HL-5286

Edwin I. Hatch Nuclear Plant  
Third 10-Year Interval Inservice Inspection Program  
Request for Relief

**GEORGIA POWER COMPANY  
HATCH NUCLEAR PLANT, UNITS 1 & 2  
THIRD 10-YEAR INTERVAL  
REQUEST FOR RELIEF NO. RR-18**

HATCH UNIT 2-RPV CORE SPRAY NOZZLE 2N5A,B

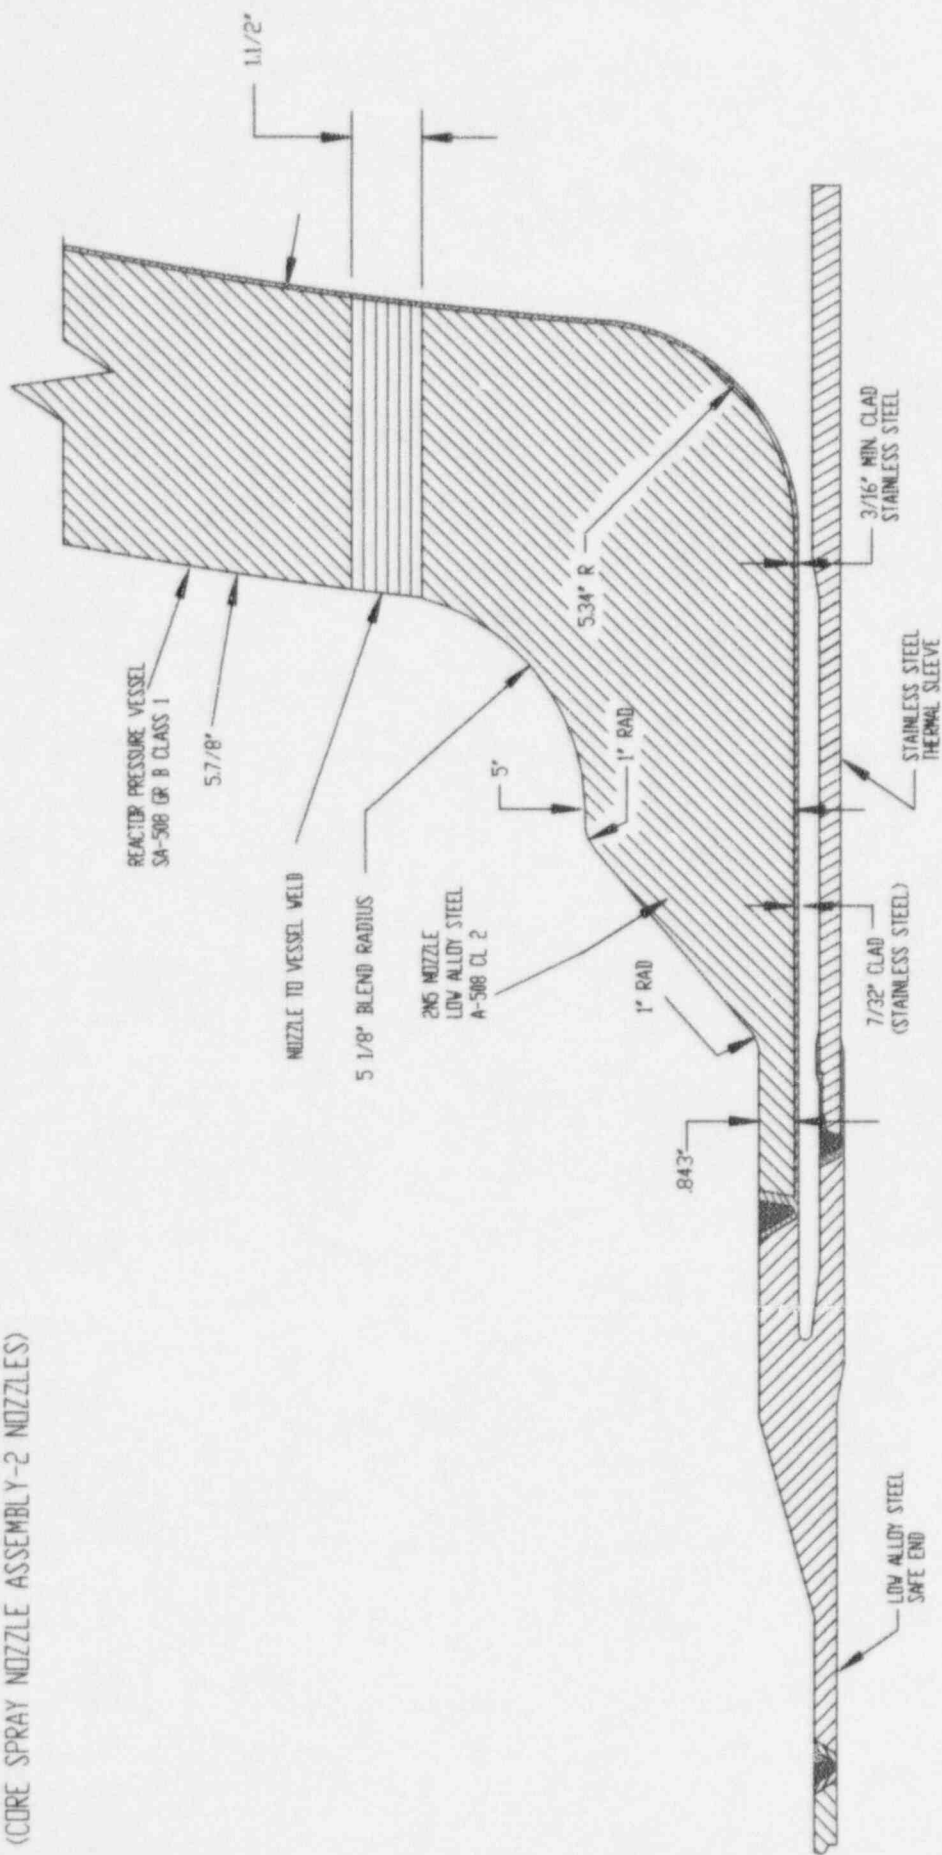
**2N5A, B - Core Spray Nozzle-To-Vessel Welds** - For this nozzle configuration, the weld is located such that ultrasonic scanning can be performed on the RPV vessel, on the weld, and on a small portion of the nozzle. For this configuration, approximately 80% of the required examination volume is scanned from the one side. (See Figure 12).

HATCH UNIT 1-TOP HEAD SPRAY NOZZLE N6A,B

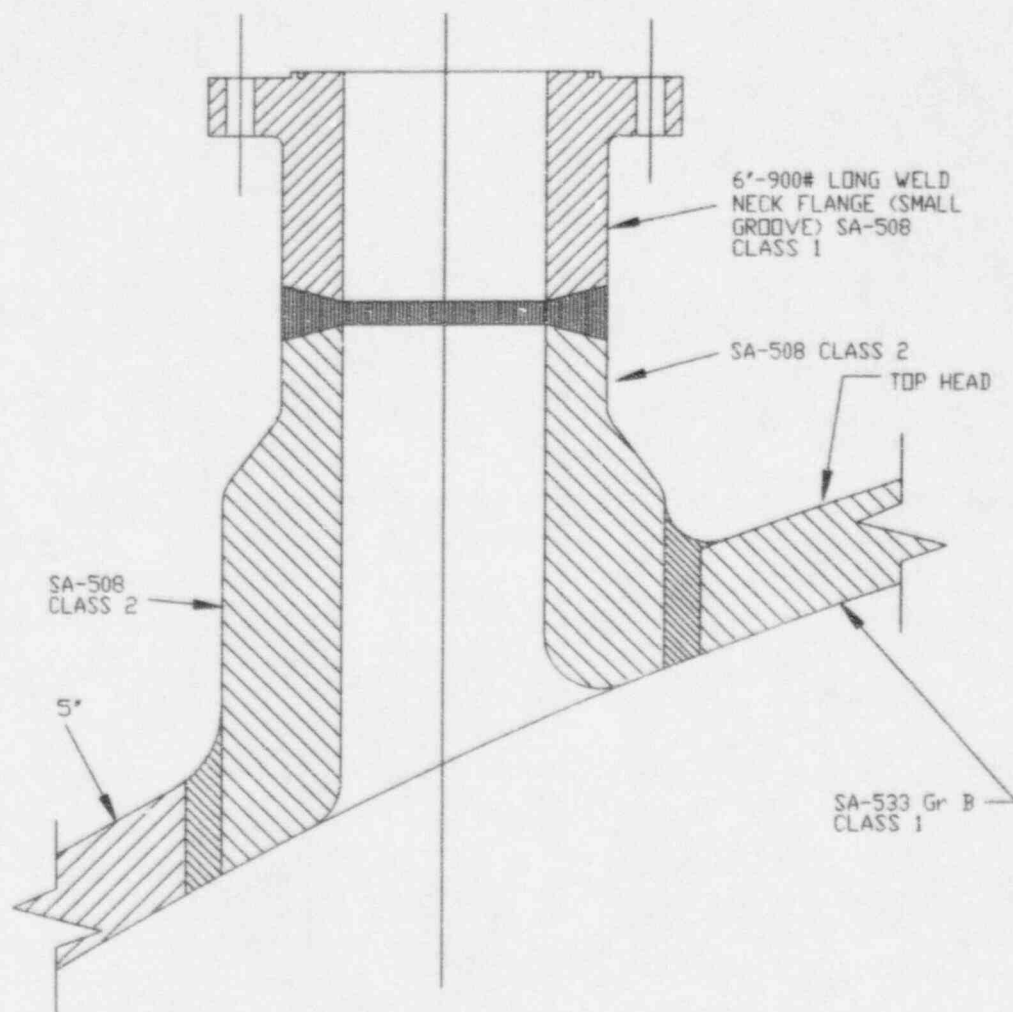
**N6A, B and N7 - RPV Head Nozzles** - These small nozzles located on the RPV head have a configuration such that coverage from one side is only approximately 40 to 50% for the N6A, B nozzles and 50% for the N7 nozzle. An evaluation of the configuration shows that these small nozzles have a very short radius. With this configuration, scanning can only be performed on the head and possibly a portion of the weld. (See Figures 1, 13 and 14).

HATCH UNIT 1-JET PUMP INSTRUMENTATION NOZZLE N8A,B

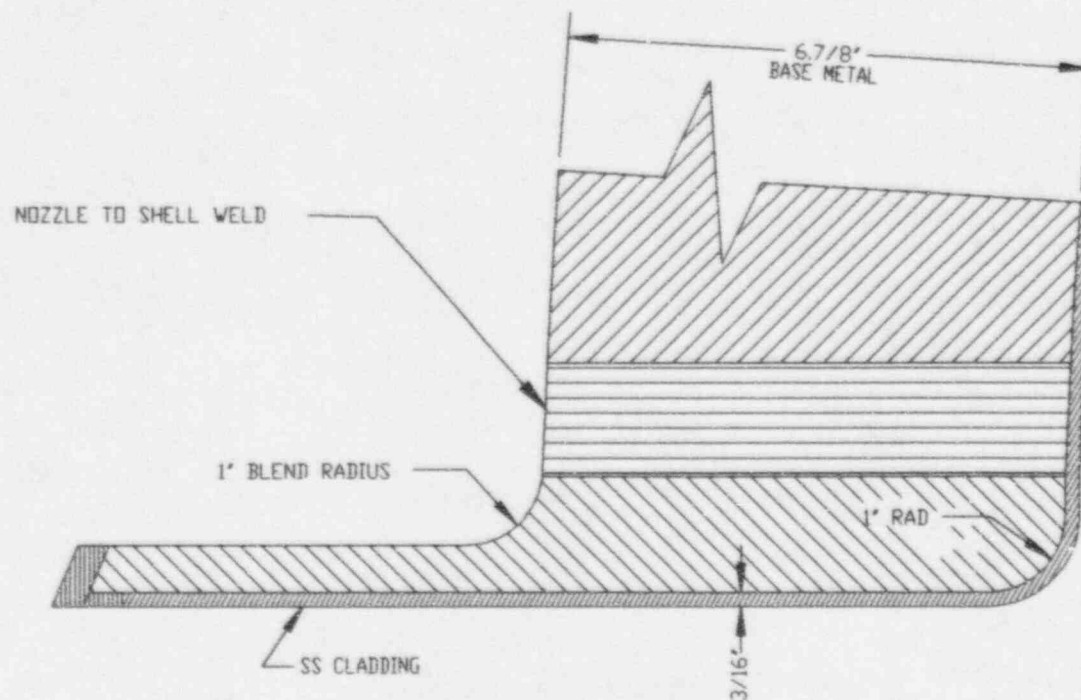
**N8A-B - Jet Pump Instrument Nozzles** - These small nozzles have a configuration such that coverage from one side is in the range of 50 to 60%. An evaluation of the configuration shows that these small nozzles have a very sharp radius. With this configuration, scanning can only be performed on the shell and possibly a portion of the weld. (See Figures 1 and 15).

HATCH UNIT 1-RPV CRD HYD SYSTEM RETURN NOZZLE N9

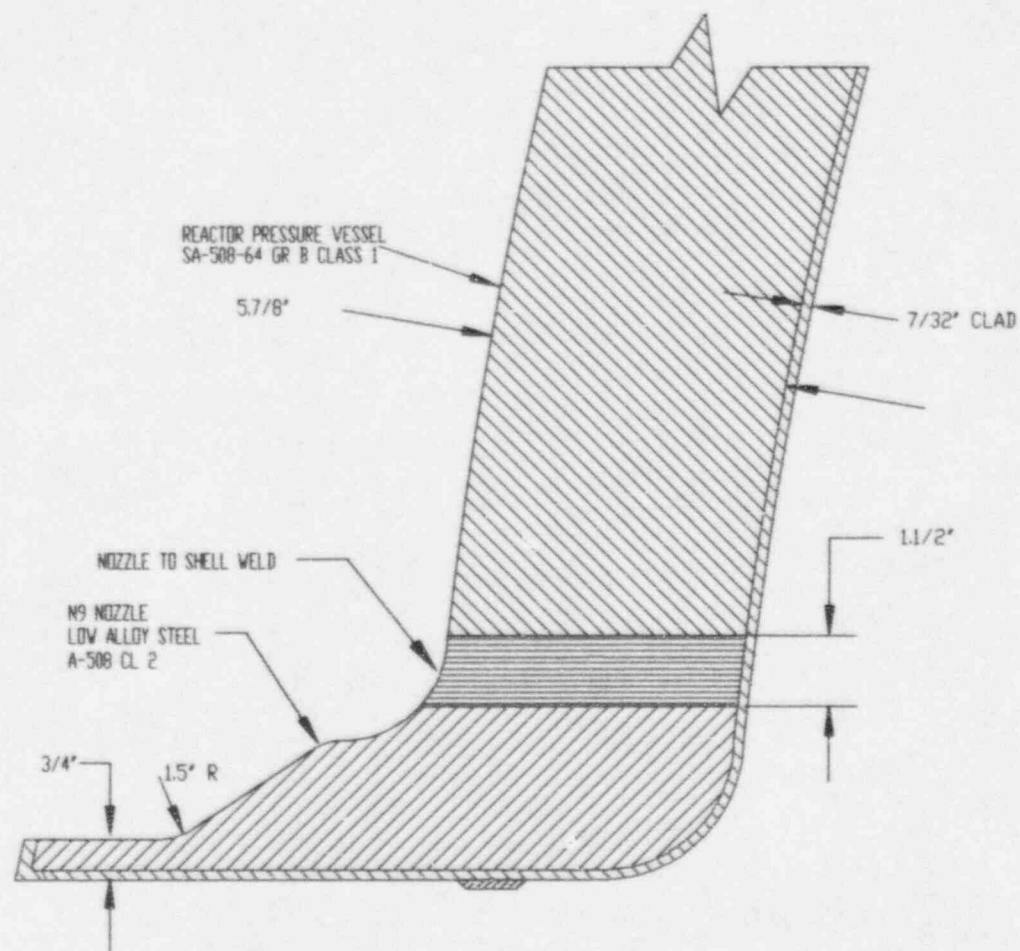
**N9 - CRD Nozzle-To-Vessel** - For this nozzle configuration, the weld is located in the curved blend radius, such that, ultrasonic scanning can only be performed on the RPV up to the point where the curvature begins. For this configuration, approximately 50 to 60% of the required examination volume is scanned from the one side. (See Figures 1 and 16).

HATCH UNIT 2- TOP HEAD SPRAY NOZZLE 2N6A,B

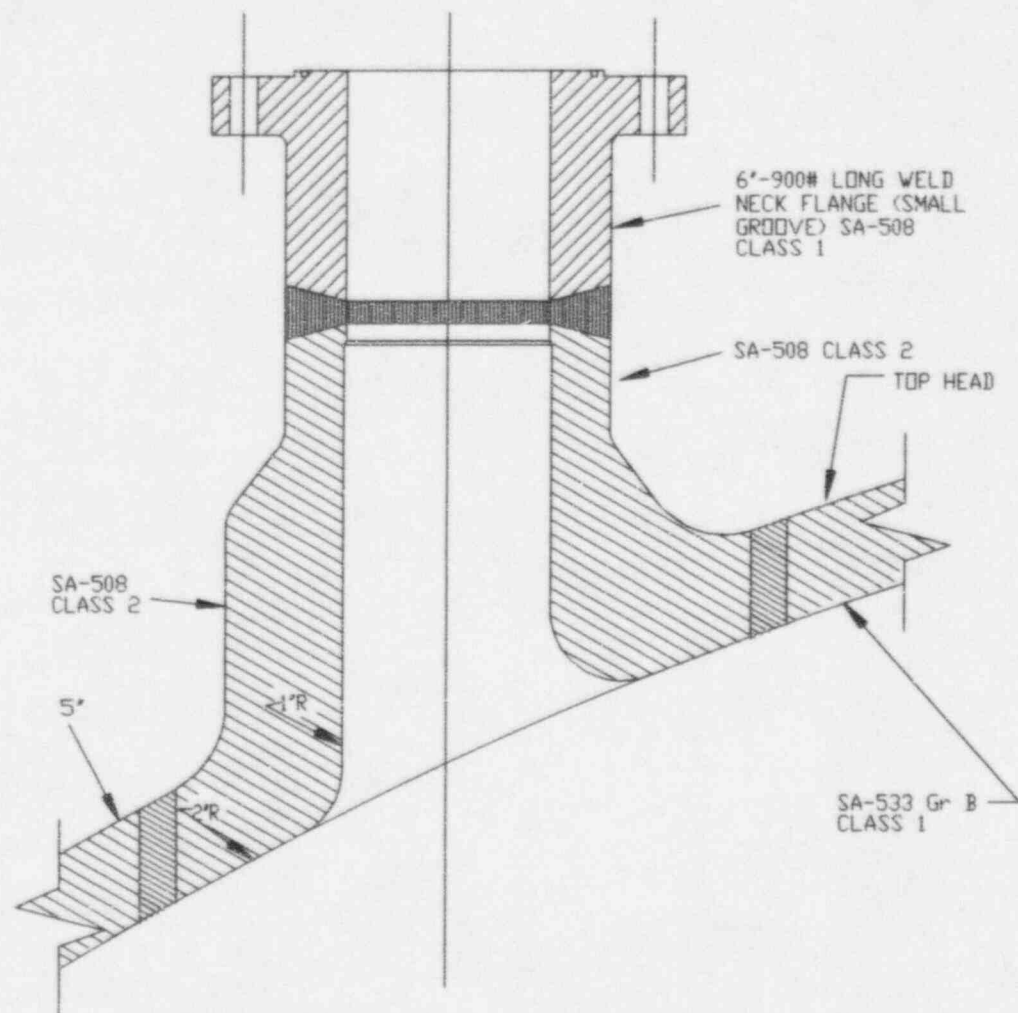
**2N6A, B and 2N7 - RPV Head Nozzles** - These small nozzles located on the RPV head have a configuration such that coverage from one side is only approximately 40 to 50% for the N6A, B nozzles and 50% for the 2N7 nozzle. An evaluation of the configuration shows that these small nozzles have a very short radius. With this configuration, scanning can only be performed on the head and possibly a portion of the weld. (See Figures 17 and 18).

HATCH UNIT 2-JET PUMP INSTRUMENTATION NOZZLE 2N8A,B

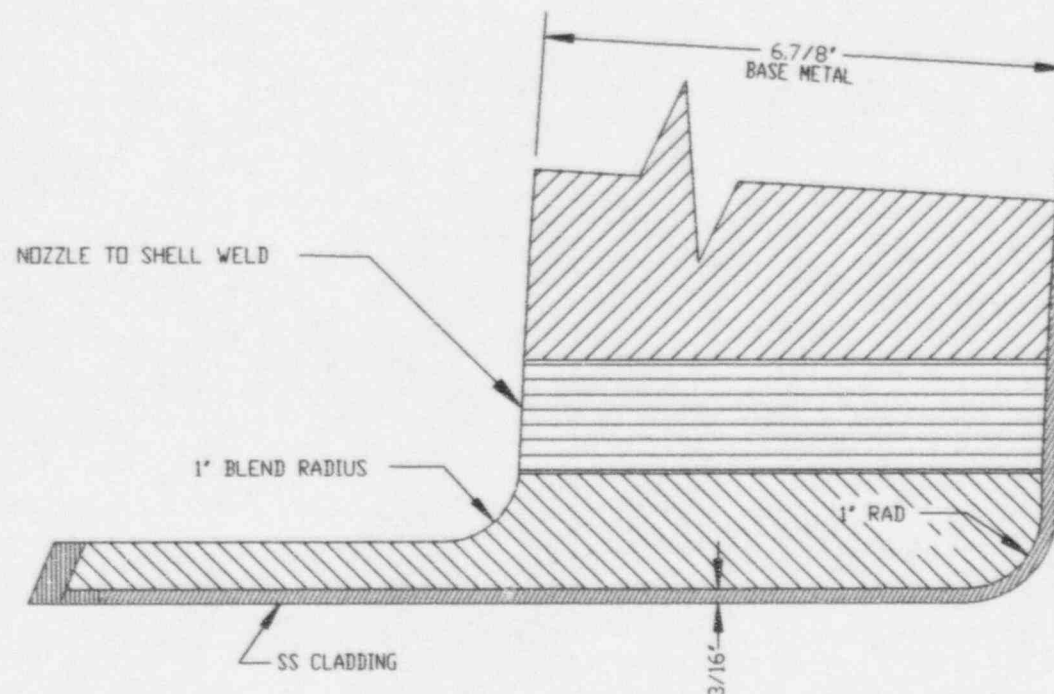
**2N8A, B - Jet Pump Instrument Nozzles** - These small nozzles have a configuration such that coverage from one side is the range of 50 to 60%. An evaluation of the configuration shows that these small nozzles have a very sharp radius. With this configuration, scanning can only be performed on the shell and possibly a portion of the weld. (See Figure 19).

HATCH UNIT 2-RPV CRD HYD SYSTEM RETURN NOZZLE 2N9

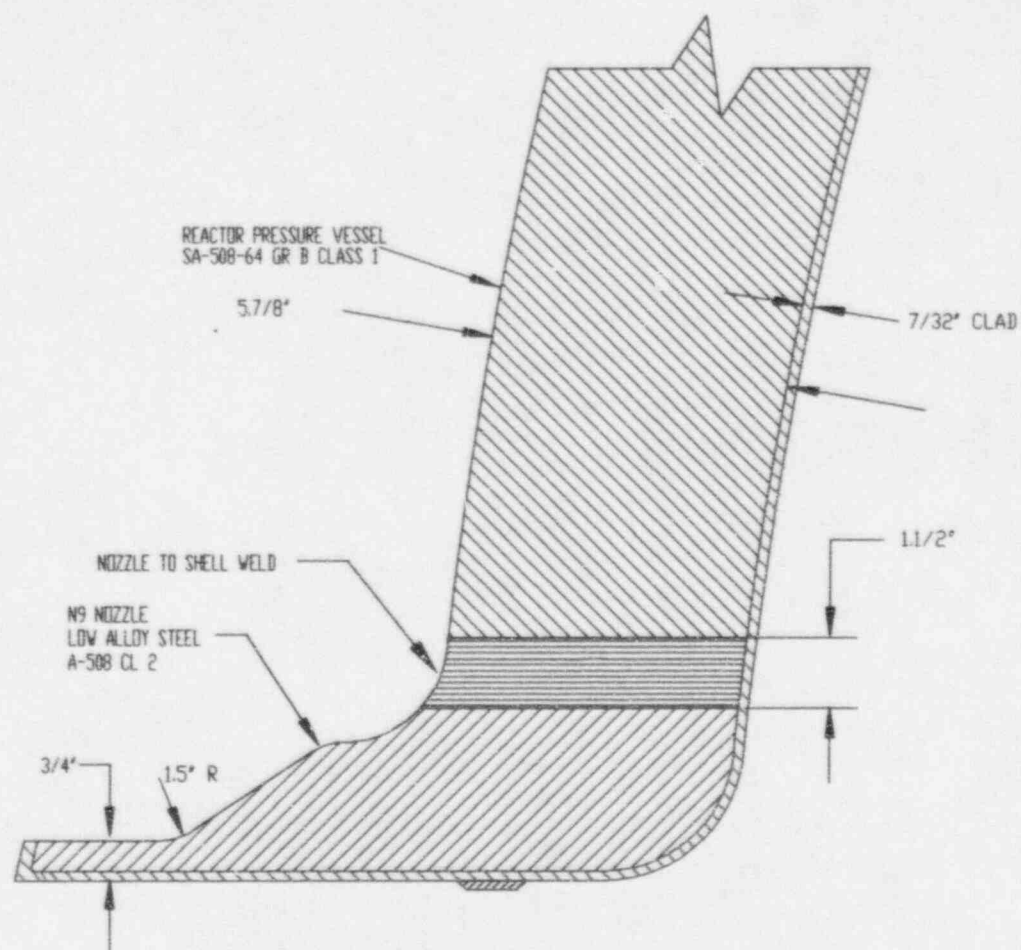
**2N9 - CRD Nozzle-To-Vessel** - For this nozzle configuration, the weld is located in the curved blend radius, such that, ultrasonic scanning can only be performed on the RPV up to the point where the curvature begins. For this configuration, approximately 50% of the required examination volume is scanned from the one side. (See Figure 20).

TYPICAL HATCH RPV NOZZLE 45 DEG. SCAN COVERAGE  
FOR BARREL TYPE NOZZLE

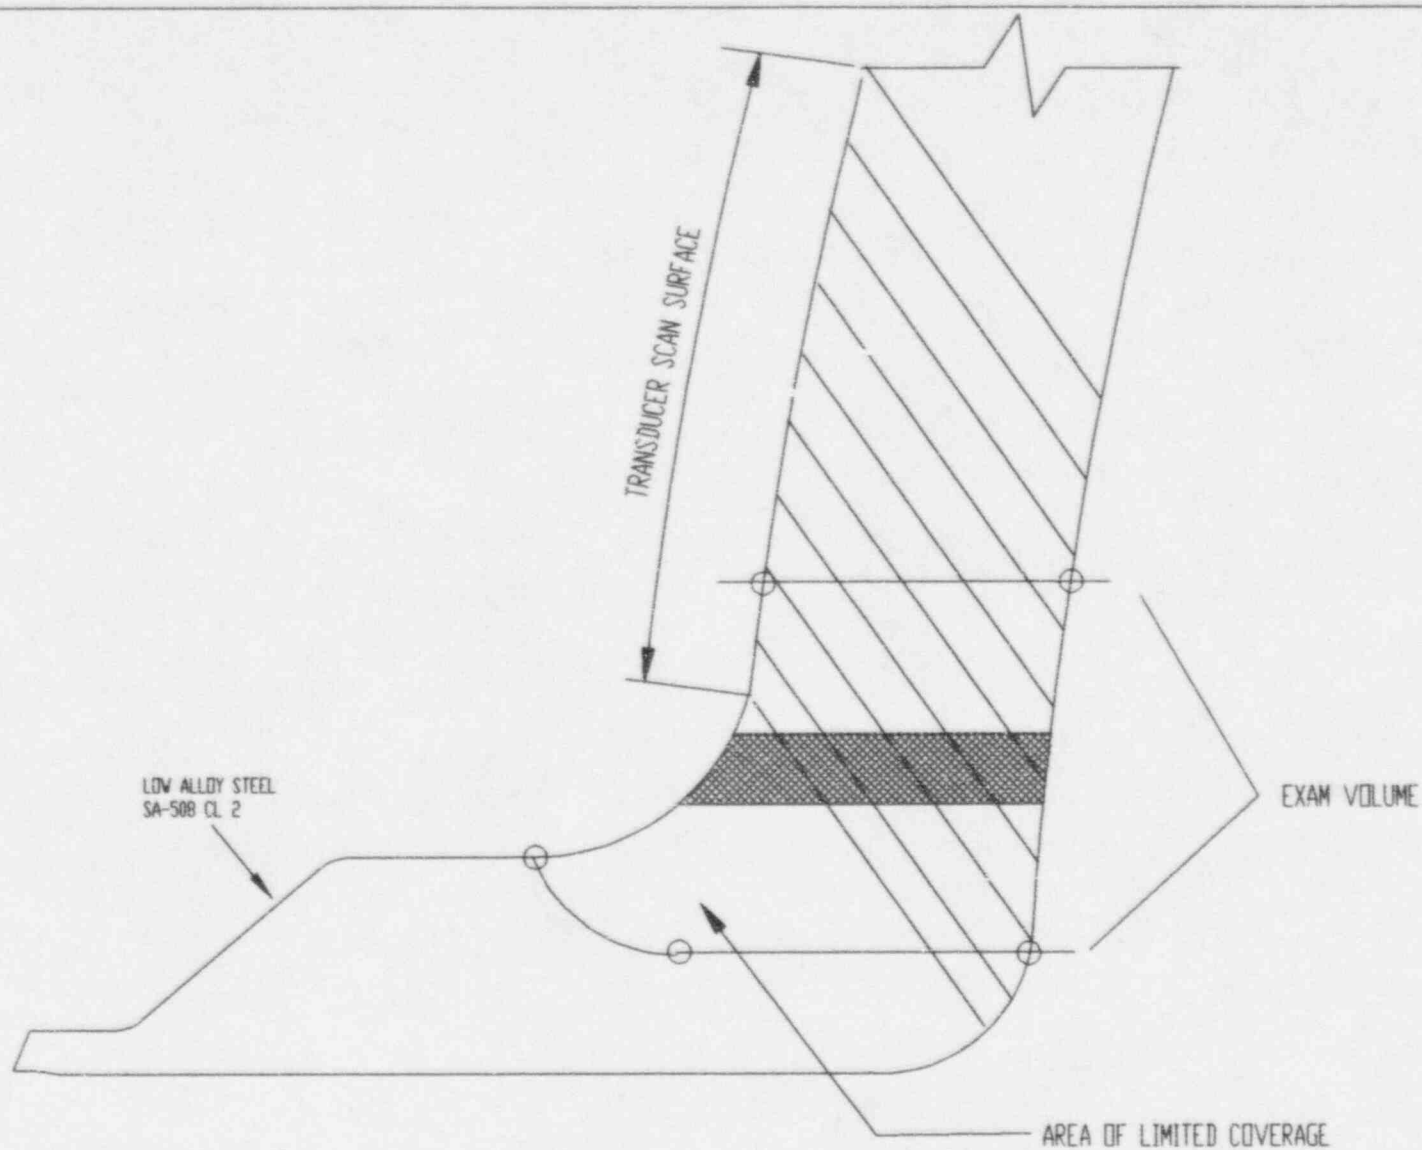
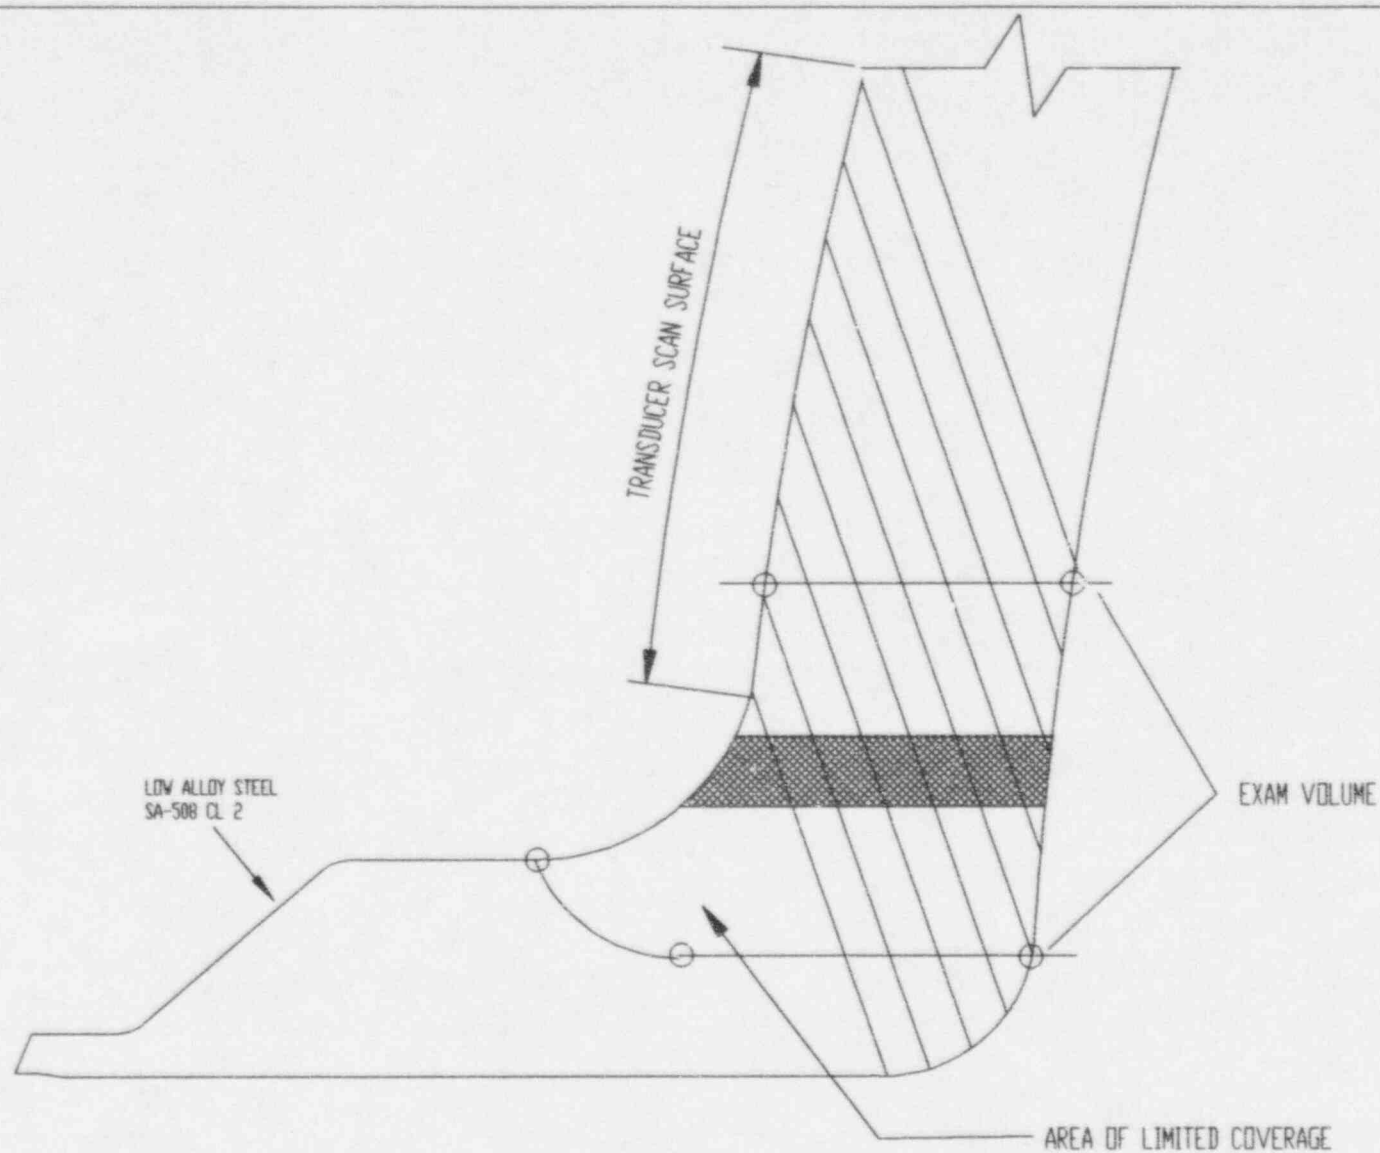
One directional coverage from the vessel side is also limited since complete coverage would require scanning from the vessel side onto the weld crown, and then onto a portion of the nozzle. However, as addressed above, once the curvature of the nozzle is reached the sound beam is mis-oriented. In most cases, Unit 1 has barrel type nozzles with the weld located in the curved blend radius while Unit 2 has flange type nozzles with the weld located in the vessel shell area. Therefore, Unit 2 welds can generally be examined from the vessel shell area, from the weld crown, and possibly from a small portion of the nozzle, while the Unit 1 welds can generally be examined only from the vessel shell area. Examples of 45 and 60 degree scan coverage for a typical flange type nozzle are shown in Figures 21 and 22 while examples of 45 and 60 degree scan coverage for a typical barrel type nozzle are shown in Figures 23 and 24. Specific geometry and limitations for each nozzle are listed below.
